EVALUATION OF PROPOSED CHANGES

Subject: Modification of the Control Room Emergency Air Treatment System (CREATS), changing of the Dose Calculation Methodology to Alternate Source Term (10CFR50.67) and revision of Ginna Technical Specification Sections 1.1, 3.3.6, 3.4.16, 3.6.6, 3.7.9, 5.5.10, 5.5.16 and 5.6.7.

This letter is a request to amend Operating License Docket # 50-244 for the R.E. Ginna Nuclear Power Plant.

Figure 1

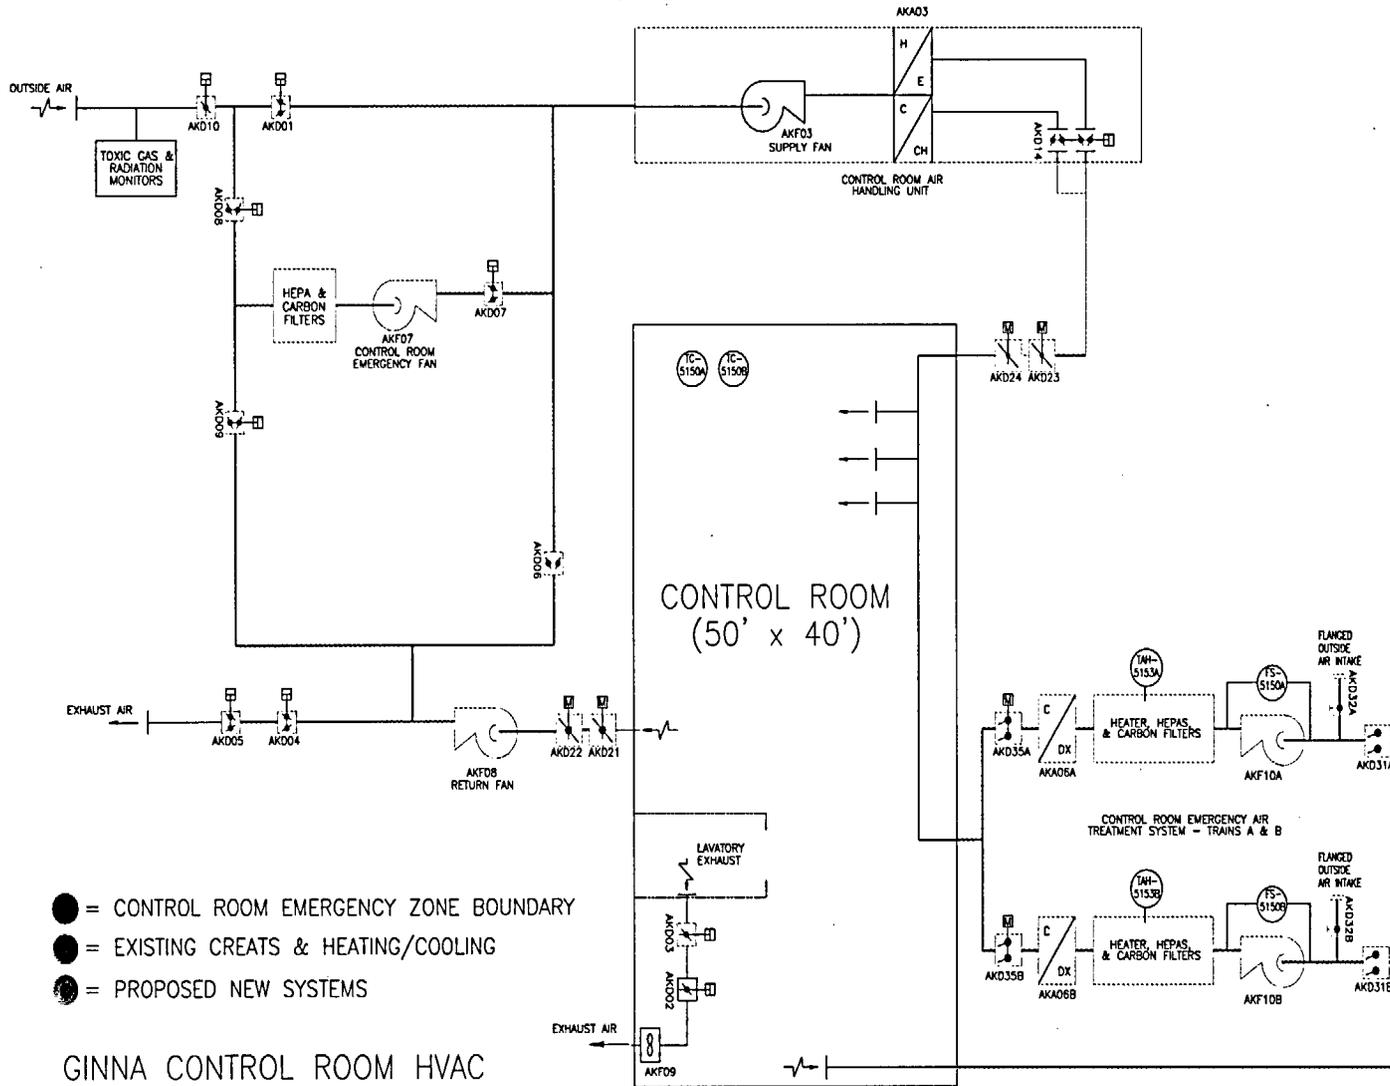
Short ducts sealed with blind flanges will be installed on the inside of the Control Room walls to provide a connection point for the interior ductwork (see A on Figure 1). Holes will then be cut from the outside of the control room wall along the internal radius of the short ducts. The interior blind flange plates will stay in place until the external system is installed and pressure tested.

Figure 3.4.16-1
Reactor Coolant DOSE EQUIVALENT I-131 Specific Activity Limit Versus Percent of RATED THERMAL POWER

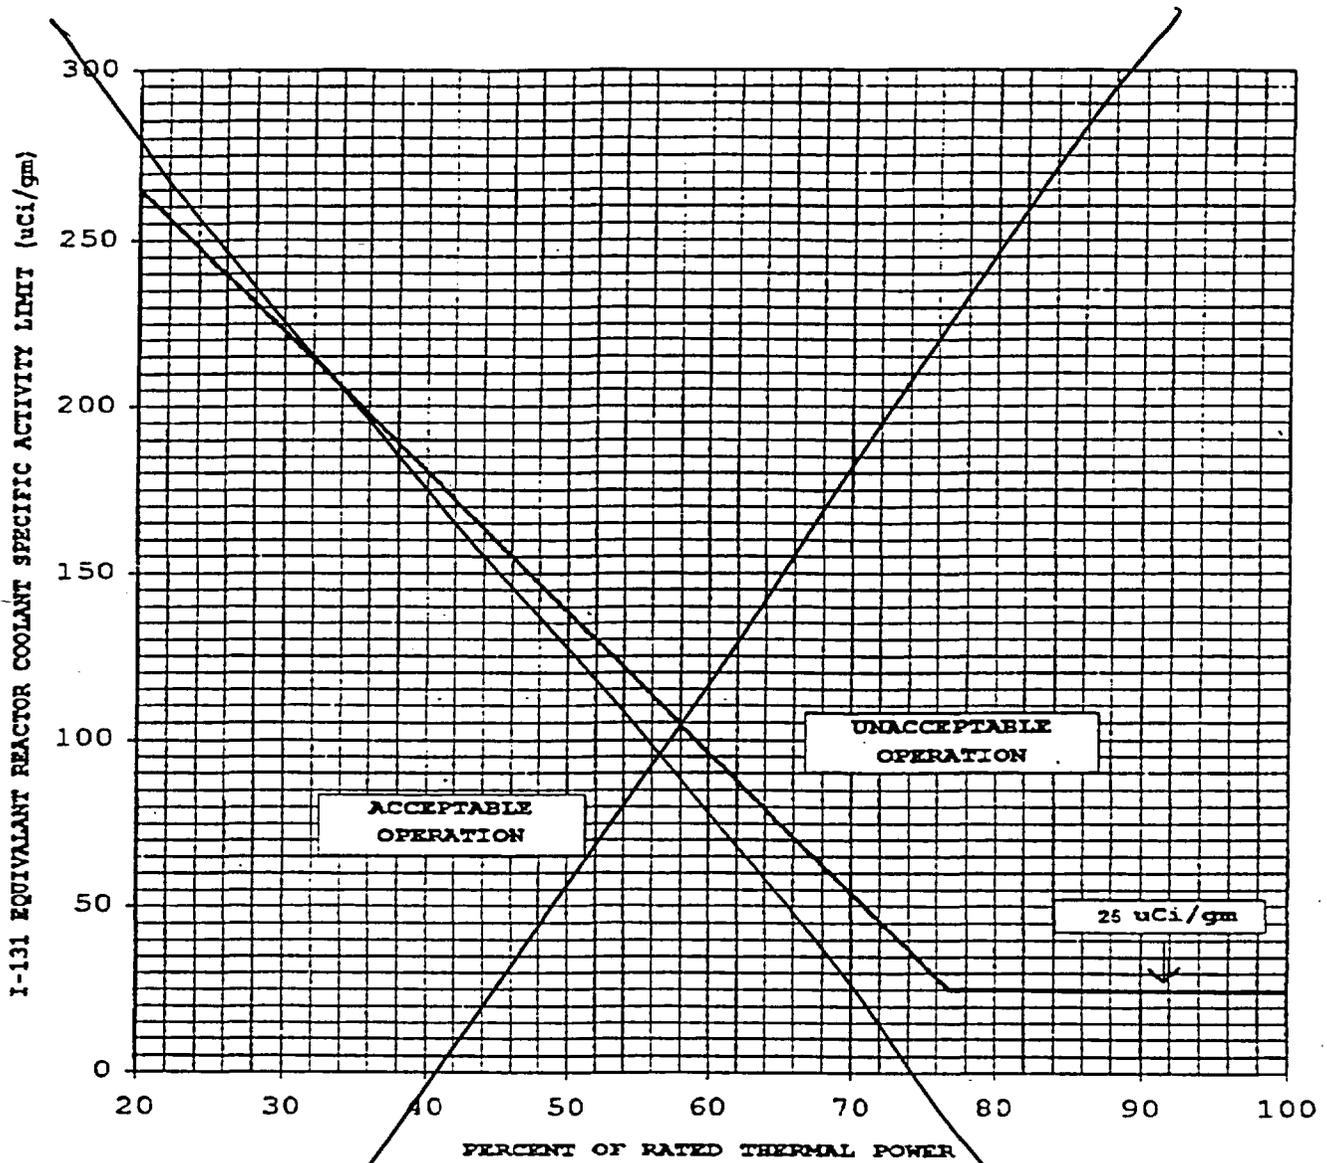
- Section 3.4.16 - RCS Specific Activity Limits will be revised to eliminate Figure 3.4.16-1 and provide a single limit for Dose Equivalent I-131 specific activity consistent with the new dose analysis.

Delete
